**GREENBRIER COUNTY BOARD OF EDUCATION
GREENBRIER COUNTY, WEST VIRGINIA**

**ALDERSON ELEMENTARY SCHOOL ADDITIONS AND RENOVATIONS
ADDENDUM #3
OCTOBER 12, 2022**

THRASHER PROJECT #060-10180

Model: **17-109WL** Item #: _____
 Project: _____ Qty: _____

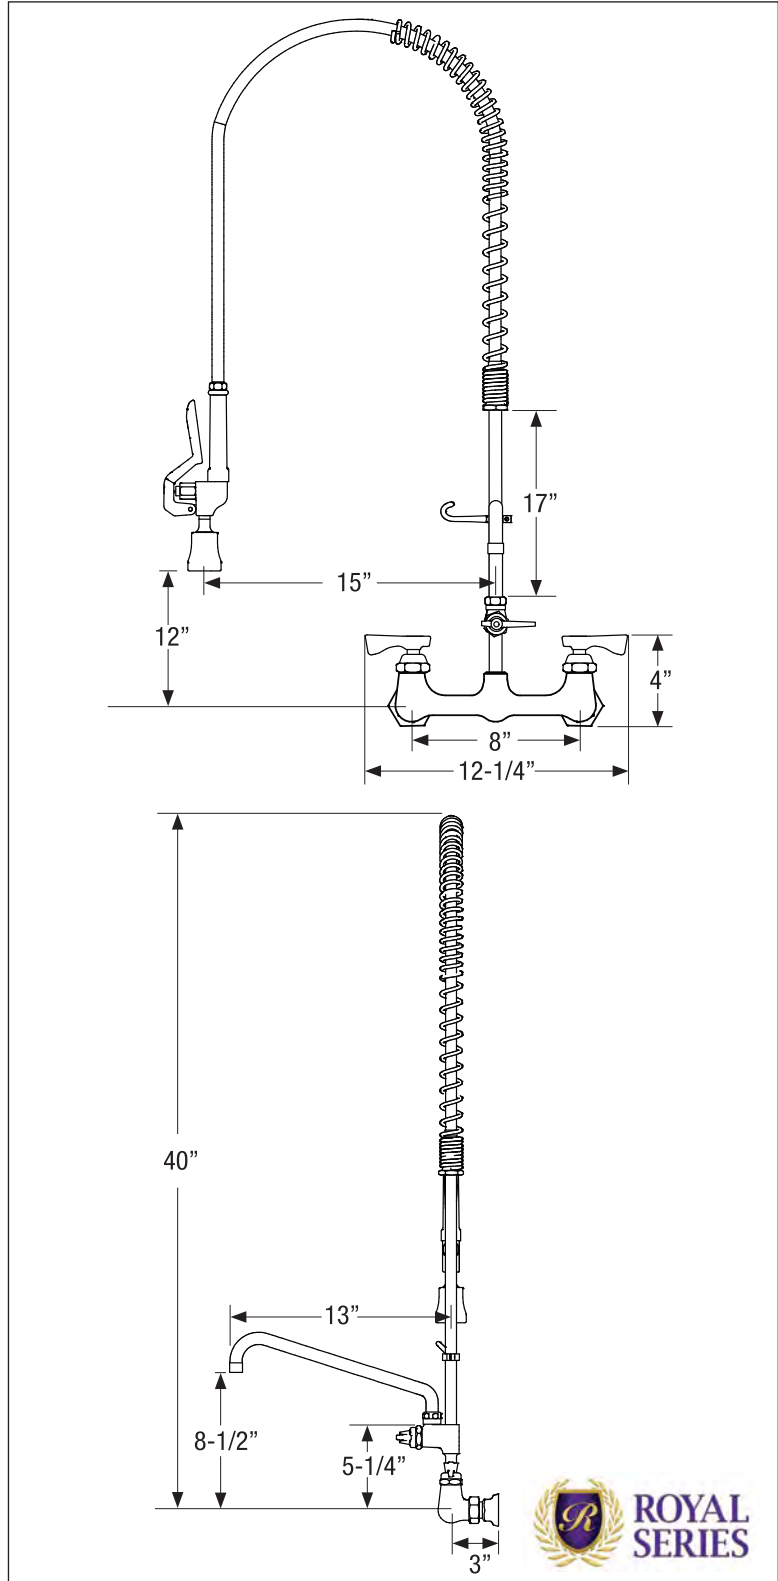
Q9. On the soiled dish table there is no mention of the required faucet. Item # 6

Q11. On the 3-compt. sink #10, for options it only shows for faucets a quantity of 2 but no specs. Also it shows a "Y" for overshelves but doesn't indicate the quantity, length & depth of the overshelves.

A11. Supplemental Product Data Sheets for the faucets are included in this Addendum.

SHEET No. **C1.10**

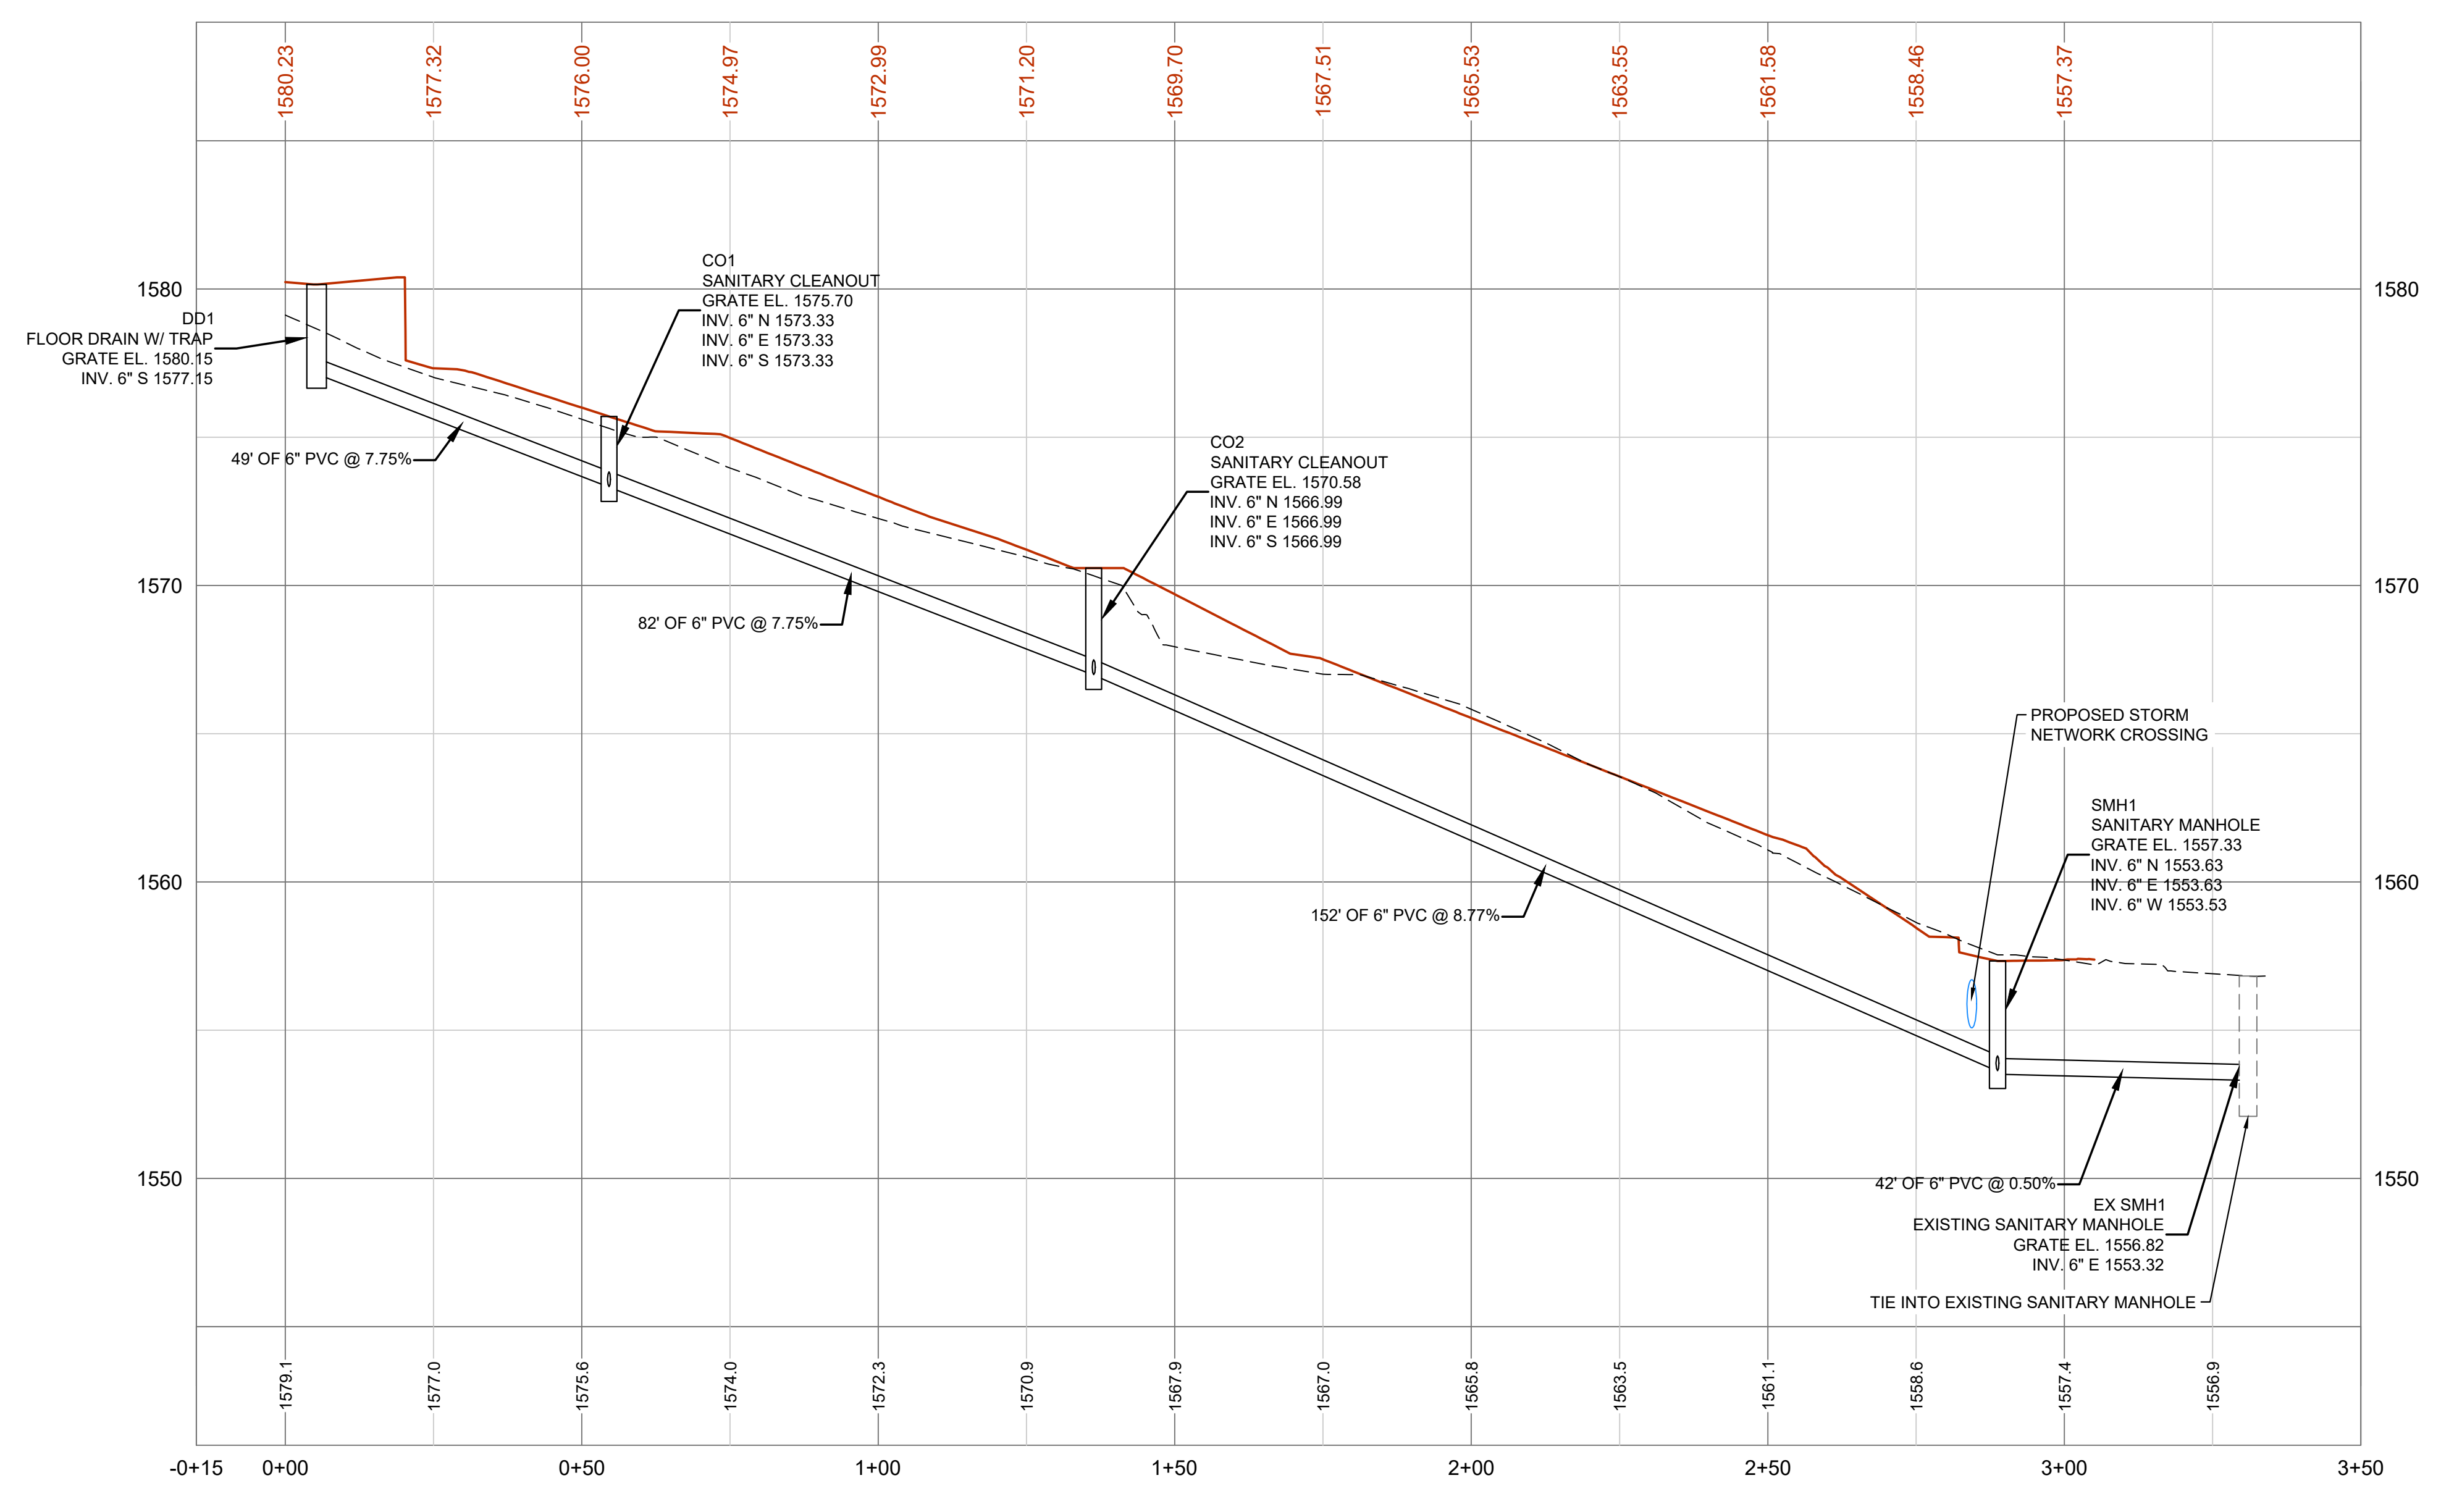
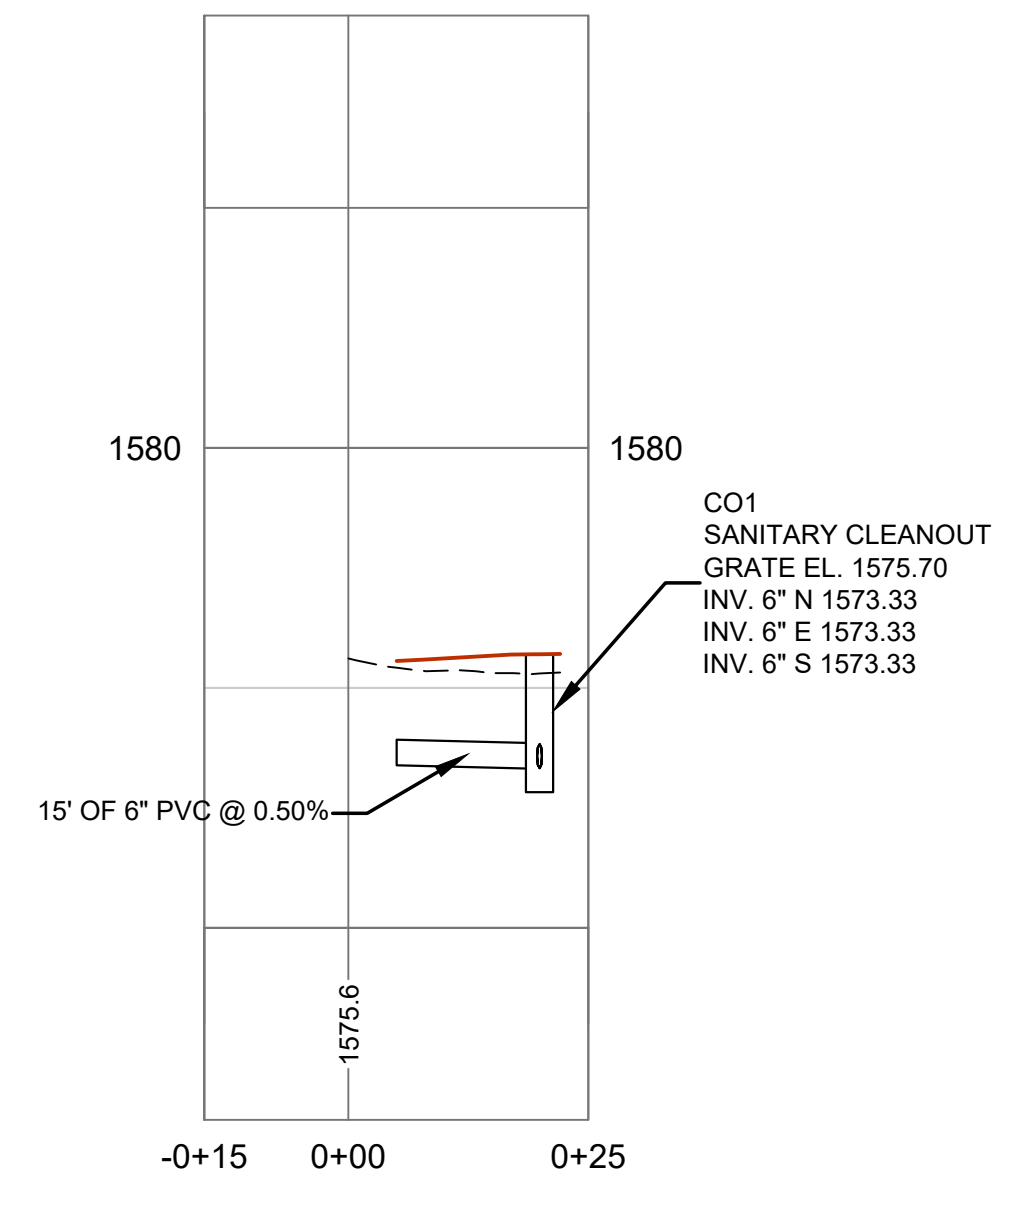
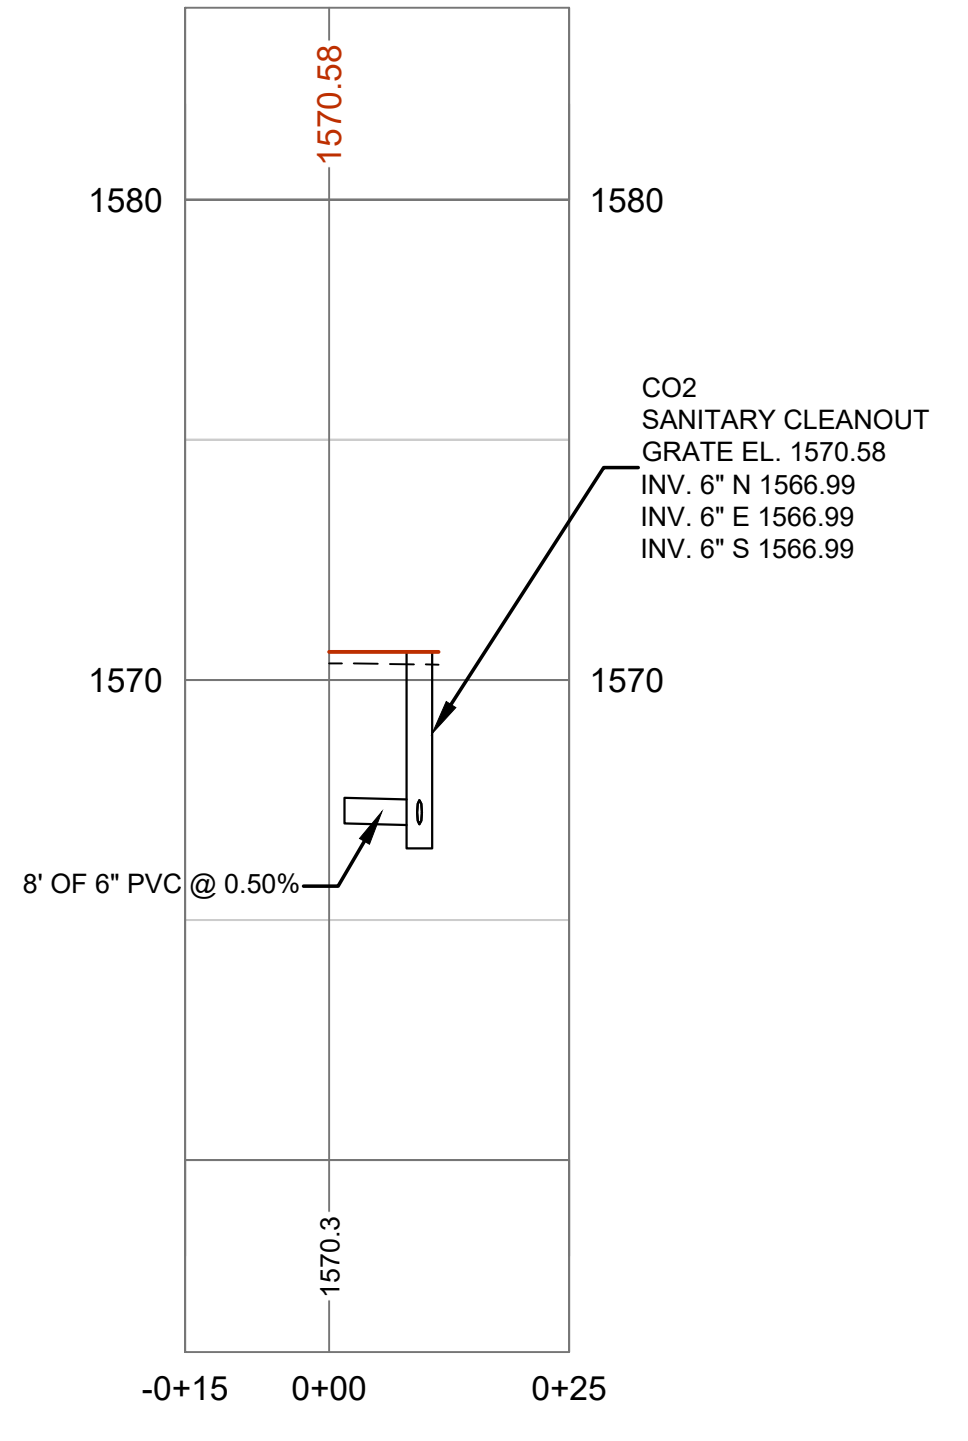
Sheet C1.10, REVISE flagged items on the updated sheet attached to this Addendum.

NO.	DATE	DESCRIPTION
1	10/06/2022	ADDITIONAL UNDERGROUND DETENTION, IDENTIFIED SEWAGE
